## BOARD OF WATER SUPPLY

Subject: September 28, 2015 United States Environmental Protection Agency (EPA)  
and Hawaii Department of Health (DOH) Response to Comments (RtC)

The Board of Water Supply (BWS) has reviewed the EPA and DOH response dated September 28, 2015 to the over 140 written comments and 29 oral comments submitted on the proposed Administrative Order on Consent (AOC) and Attachment A: Statement of Work (SOW) between the EPA and DOH with the United States Department of Navy (Navy) and the Defense Logistics Agency (DLA) (the "parties") released on June 1, 2015. Our review found inconsistencies with the final signed AOC and SOW and several issues needing clarification.

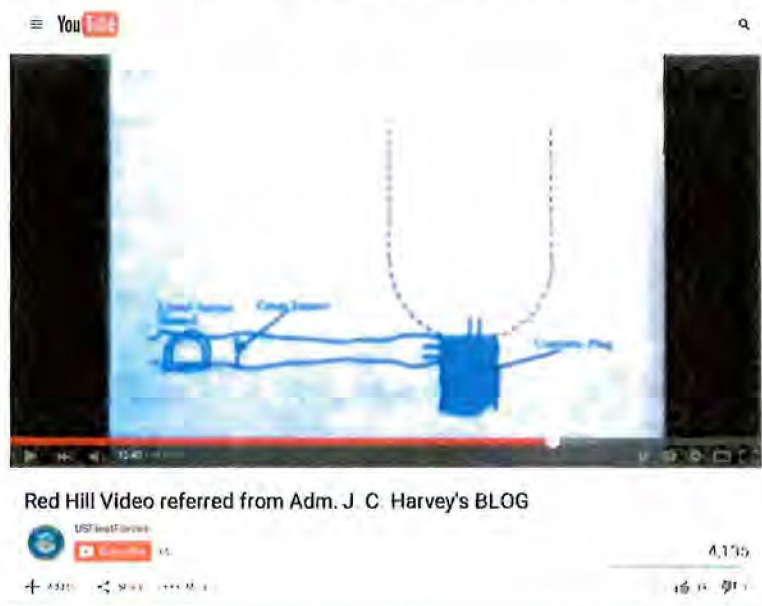
- The RtC document states *"However, the risk of catastrophic release from seismic activity at the Facility from the Tank structures is comprised of both seismic hazard and the vulnerability of the Tank structures."* While true, this is only part of the story, because seismic risk assessment does not stop at the vulnerability of the tank structures. Seismic risk is measured as the probability of some unwanted consequence, which in this case is groundwater contamination. The acceptable risk level should be a function of the severity of the consequence; in this case contamination of a sole source aquifer implies a very low tolerance for acceptable risk. In addition, the seismic risk is not limited to the vulnerability of the tank structures, but also the tunnels, pipelines, connections, engineering systems, and supporting slopes and soils.

We agree that seismic risk is calculated based two fundamental components — 1) the probability that earthquake shaking of given intensity will occur (seismic hazard), and 2) the probability that, given that shaking intensity, some tank component or associated piping or valve will fail (structural fragility), causing leakage and groundwater contamination (consequence). The total seismic risk is calculating by convolving the seismic hazard and the seismic fragility, and comprises a complex, engineering-intense undertaking. Formal seismic risk assessment is typically done by specialist firms. These results are then carefully and independently peer-reviewed.
